STAFF RECOMMENDATION
3546 Richland Avenue
Lot 18, Richland Hall Development
September 18, 2019

Application: New Construction—Infill
District: Richland-West End Neighborhood Conservation Zoning Overlay
Council District: 24
Base Zoning: RS7.5
Map and Parcel Number: 104090305
Applicant: Chad Gore, Mike Ford Builders
Project Lead: Jenny Warren, jenny.warren@nashville.gov

Description of Project: Application to construct a new single-family infill with an attached garage at basement level.

Figure 2. Overall site plan for the 22 infill houses planned for the Richland-West End Neighborhood Conservation Zoning Overlay. The red box indicates lot 18, the site currently under consideration.

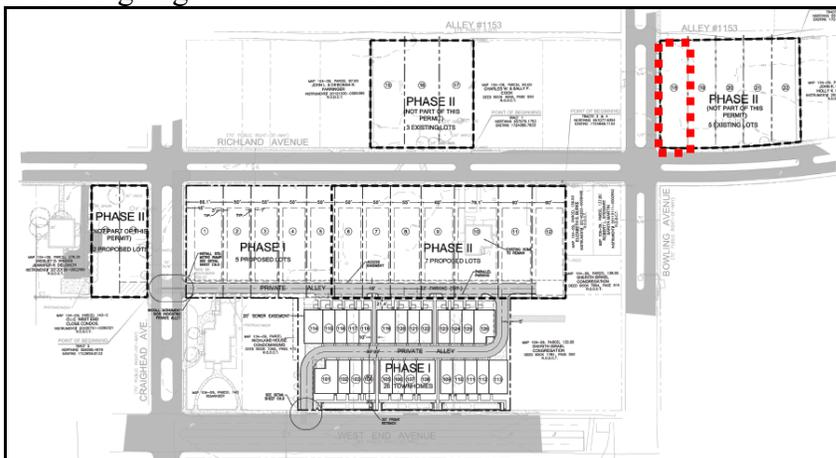
Height & Scale: The proposed infill will be two-stories and will have a maximum height of about thirty-four feet (34') above the foundation height, with eave heights of approximately twelve feet to sixteen feet (12'-16'), above the foundation at the front. (Figure 1) Staff finds that the proposed height is similar to the heights of historic houses in the immediate vicinity, which range from twenty to thirty-seven feet (20'-37') tall from grade. It is also in keeping with what has been approved in the past for the infill houses in this development.

Because of the steep slope of the lot, the foundation height will vary from about two feet (2') on the front, to about ten feet (10') tall near the back of the infill. At the rear, a full height walk-out basement level will be clad in brick, rather than foundation material. Staff recommends inspection of the foundation and the finished floor height to ensure that the height of the foundation at the front is appropriate for the historic context.

Staff recommends verification of the construction height of the foundation and floor systems in the field to ensure that the finished floor line of the new construction is compatible with the historic context. With this condition, staff finds that the height and scale meet Section II.B.1.a and II.B.1.b of the design guidelines.

Figure 3. The proposed footprints and setbacks for Lots 18-22 of the Richland Hall development.

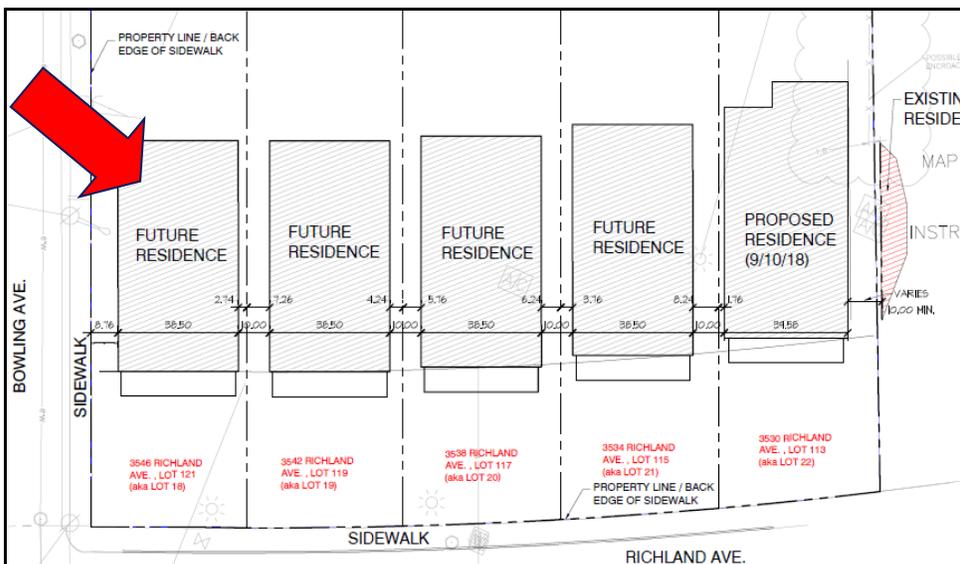
The front setback for the five infills gradually steps back, matching the curve of Richland Avenue and transitioning the front setbacks to the historic house at 3526 Richland Avenue (Figure 3). The first infill, at 3530 Richland Avenue, lot 22, was approved to have a front setback similar to the front setback of the historic house at 3526 Richland Avenue, when the curve is taken into account. The next three houses at 3534, 3538 and 3542 Richland Avenue were approved with front setbacks that are consistent, considering the curve (Figures 3 and 4). The setback of the proposed infill at 3546 Richland (lot 18), is proposed with its front wall consistent with the front walls of the other infill. As with all infill, staff recommends that the field staking be checked by MHZC staff in the field, to ensure that the proposed setback maintains the appropriate consistent setback shown in Figures 3 and 4.

The applicant is requesting a side setback determination for both the right and left sides. The existing house at 3526 Richland Avenue is shifted on the lot and sits less than two feet (2') from the shared side property line with the recently constructed infill at 3530 Richland Avenue. Because of this and because the same developer owns all five of these lots, the applicant proposed to shift all the infills in this section of the development to maintain a ten foot (10') separation between each house. The Commission has already approved setback determinations for three of the previously approved infill houses on this block (lot #20 did not require a setback determination). The Commission approved a similar set of setbacks for Lots 1, 2, 3, 4, 5, 6, and 7 of this development.

The proposed infill at 3546 Richland is the corner lot, with the left side property line along Bowling Avenue. The side of the house along Bowling is proposed to be about eight feet, six inches (8'6") from the property line, while base zoning requires ten feet (10'). The Commission has reduced a side-street setback to less than ten feet (10') where there are nearby corner houses with side setbacks of less than ten feet (10') along the side-street. In this case, other houses at this corner sit as close as seven feet, six inches

(7'6") to the Bowling Avenue property line, so staff finds that an eight-foot, six inch (8'6") side setback could be appropriate. The house is proposed to sit three feet (3') from the right-side property line. The neighboring house at #3542 Richland (lot 19) sits seven feet (7') from this property line, thus allowing a three-foot (3') side setback here will maintain a ten foot (10') distance between the two houses, as per Figure 3.

Staff finds that the proposed setbacks to be similar to the immediate historic context and to meet Section II.B.1.c. of the design guidelines.

Figure 5. Left Elevation, along Bowling Avenue. Note lattice feature where staff recommends windows.

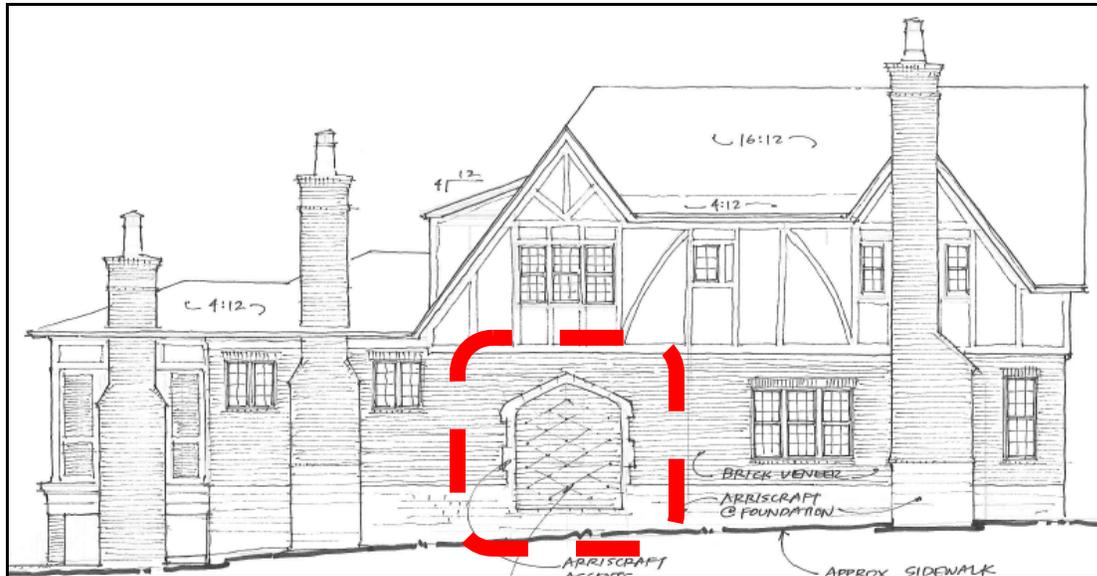
Proportion and Rhythm of Openings: The proposed windows on the infill are generally at least twice as tall as they are wide, thereby meeting the historic proportion of window openings. All window groupings have a four to six inch (4"-6") mullion in between the individual window openings. On the left elevation, facing Bowling Avenue, there is a large expanse of wall with no openings where the applicant is proposing a wire lattice system. Staff recommends that this lattice feature be replaced with windows, as the guidelines require a window or door opening approximately every eight to thirteen feet (8'-13'). The Commission has approved blind windows on side elevations elsewhere in this development, but because this side elevation will be highly visible along a side street,

staff recommends installing true windows. With the addition of windows to replace the lattice feature on the Bowling Street elevation, staff finds that the infill's proportion and rhythm of openings meets Section II.B.1.g. of the design guidelines.

**LEFT ELEVATION
(BOWLING AVE.)**

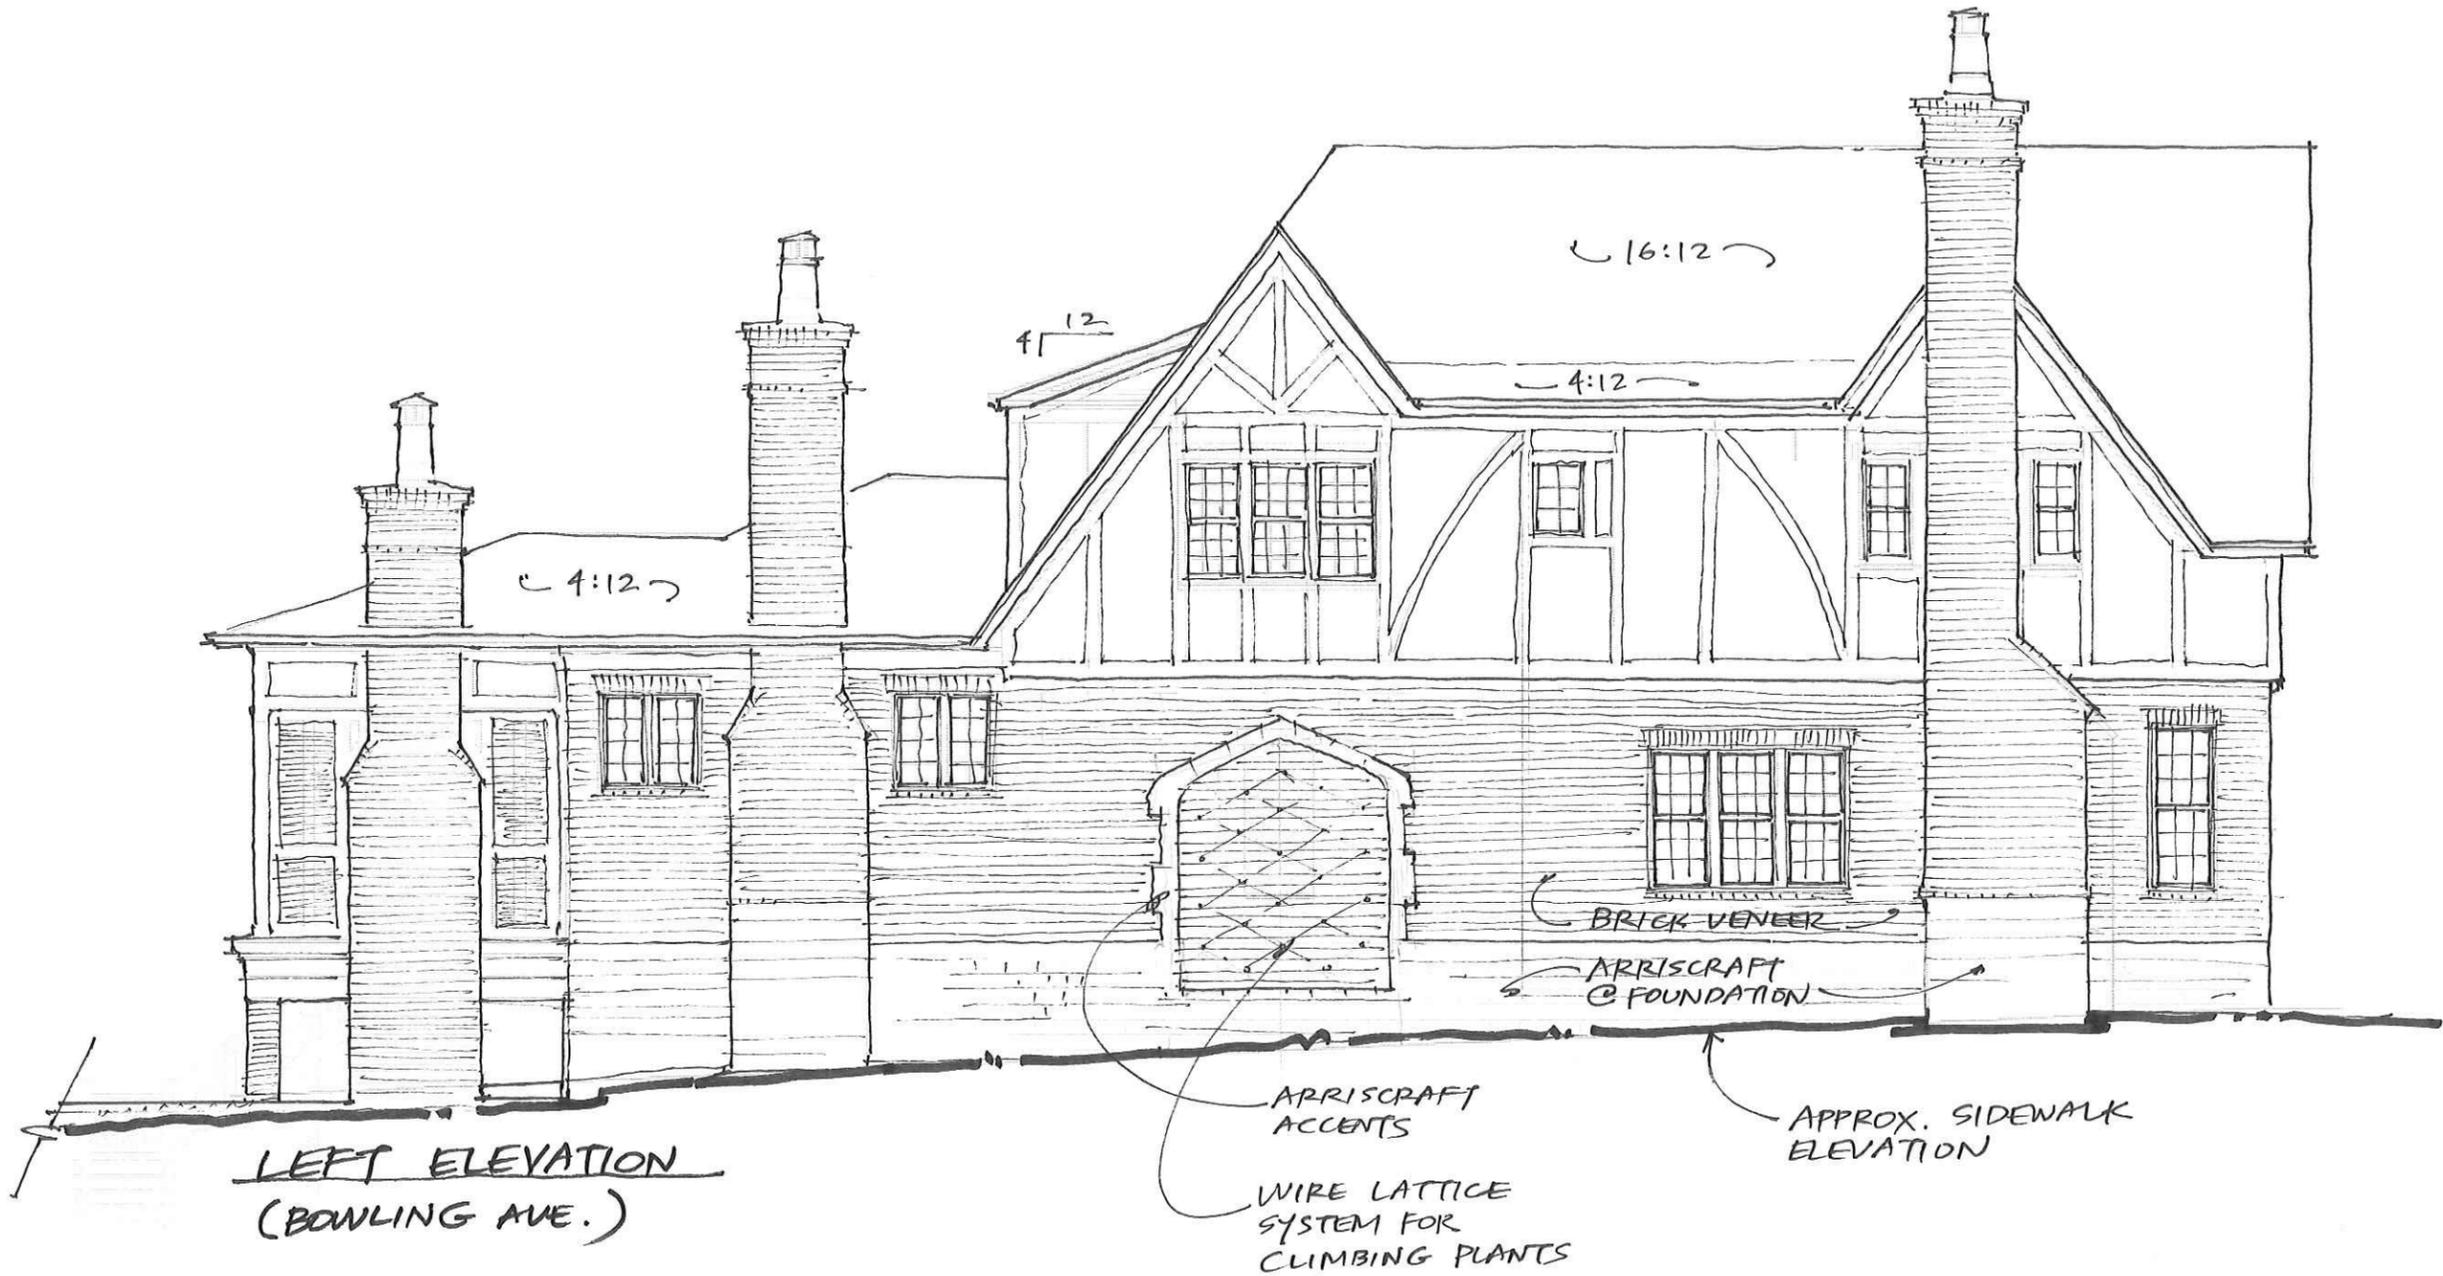
WIRE LATTICE SYSTEM FOR CLIMBING PLANTS

1. The finished floor height be consistent with the finished floor heights of neighboring historic houses, to be verified by MHZC staff in the field; and
2. Staff inspect the front setback during staking to ensure the setback's compatibility with the historic house at 3526 Richland Avenue and the new infill houses at 3530, 3534, 3538 and 3542 Richland Avenue; and
3. Staff approval of stone and brick samples, all windows and doors, the garage doors, the roof shingle color, the materials of the porch floor and steps, and the material of the driveway and walkway; and
4. Windows shall be added to the Bowling Avenue elevation, in the location of the proposed lattice feature
